This submittal covers information on ATTS (Section III) and the proposed plant design modifications (Section IV) being performed at Plant Hatch through the installation of ATTS during the 1984 refueling outage. This report will be updated for the 1985 refueling outage to include the remaining modifications being performed through the installation of ATTS.

The purpose of this submittal is to provide the bases for the proposed modifications and to provide Georgia Power Company's (GPC) proposed revisions to the Technical Specifications.

IV. PROPOSED PLANT MODIFICATIONS TO BE INCORPORATED INTO THE ATTS DESIGN

LOW LOW SET VALVE B21-F013H
ELEMENTARY DRAWING
REVISION TO H-17755

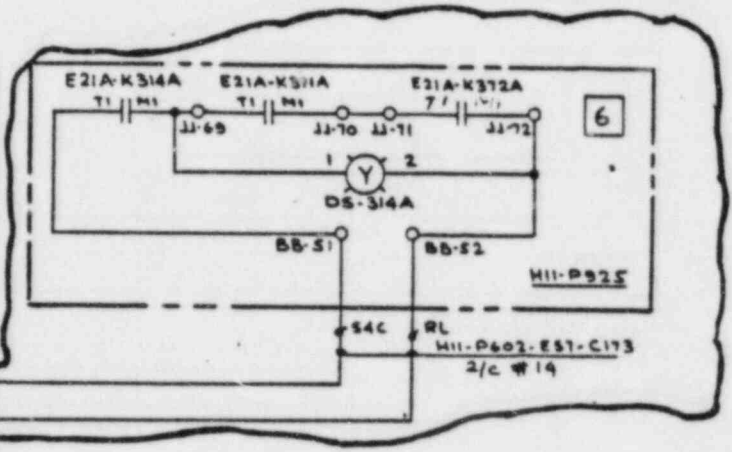
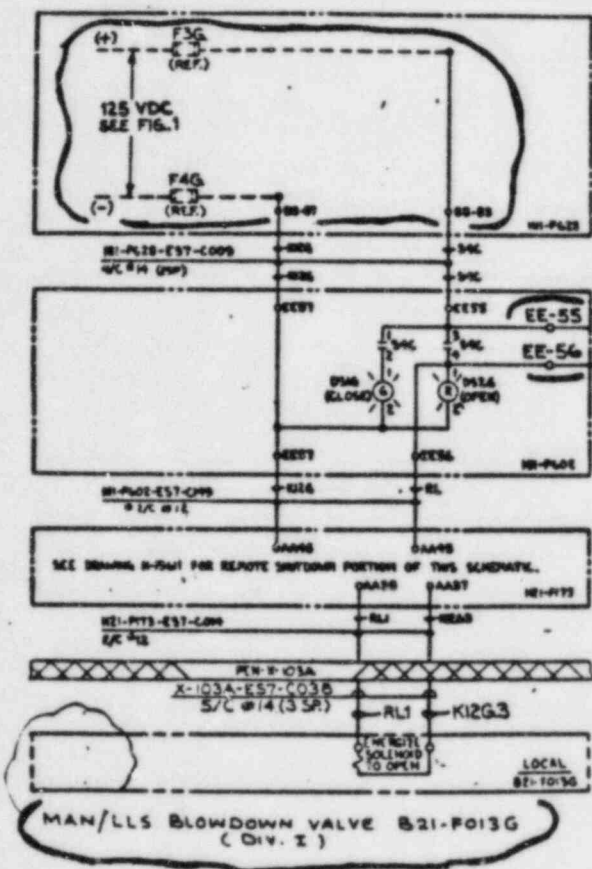
4B.1 Low Low Set Logic Design Modification (B21-N620A,B,C,D; B21-N621A,B,C,D; B21-N622A,B,C,D)

The purpose of the LLS relief logic is to mitigate the induced loads of subsequent safety/relief valve (S/RV) actuations as identified in NUREG-0661. The LLS relief logic automatically arms the designated LLS S/RVs at their LLS setpoints when any S/RV opens initially and when, concurrently, the reactor vessel steam dome pressure exceeds the scram setpoint. After arming, the reactor vessel steam dome pressure instrumentation controls the solenoid valves so that the LLS S/RVs open and close at their assigned setpoints. Technical Specifications revisions are required to accurately reflect the newly designated safety function of the selected S/RVs. However, as justified in Appendices 1 and 2 of reference 1, this modification constitutes neither an unreviewed safety question, nor a significant hazards consideration. Appendix 1 (page A1-3) of this document provides the results of the significant hazards review.
